**ECONOMIC COMMISSION FOR EUROPE
INLAND TRANSPORT COMMITTEE
World Forum for Harmonization of Vehicle Regulations (WP.29)
Working Party on General Safety Provisions (GRSG)**

PROPOSAL FOR DRAFT AMENDMENTS TO REGULATION No. 52

Transmitted by the Expert from Germany

Figure 16b

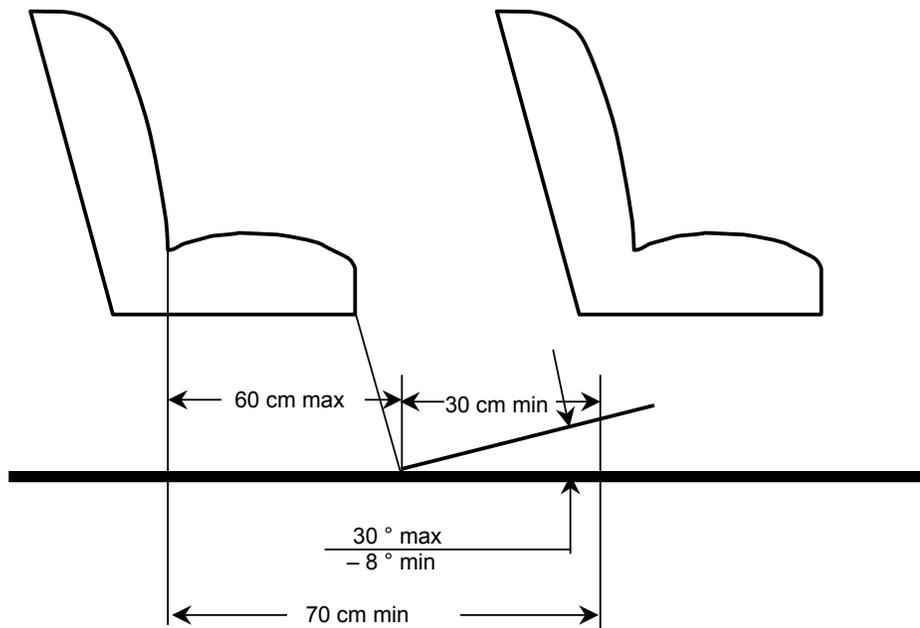
"5.7.8.5.2. For a seat behind a seat and/or a seat facing the gangway, a minimum clear foot space of at least 300 mm depth and a width according to paragraph 5.7.8.2.1. shall be provided as shown in Annex 3, figure 16b. The local presence in this space of seat legs and intrusions as provided by paragraphs 5.7.8.1.3.3 and 5.7.8.1.3.4 shall be permitted provided that adequate space remains for the passengers' feet. This foot space may partly be situated in and/or above the gangway but shall not create any obstruction when measuring the minimum gangway-width in accordance with paragraph 5.7.5. Intrusion of the seat belts and seat belt anchorages shall be allowed."

Insert a new drawing:

"Space for seated passengers **behind a seat and or/or a seat facing the gangway**"
(see paragraph 5.7.8.5.2)
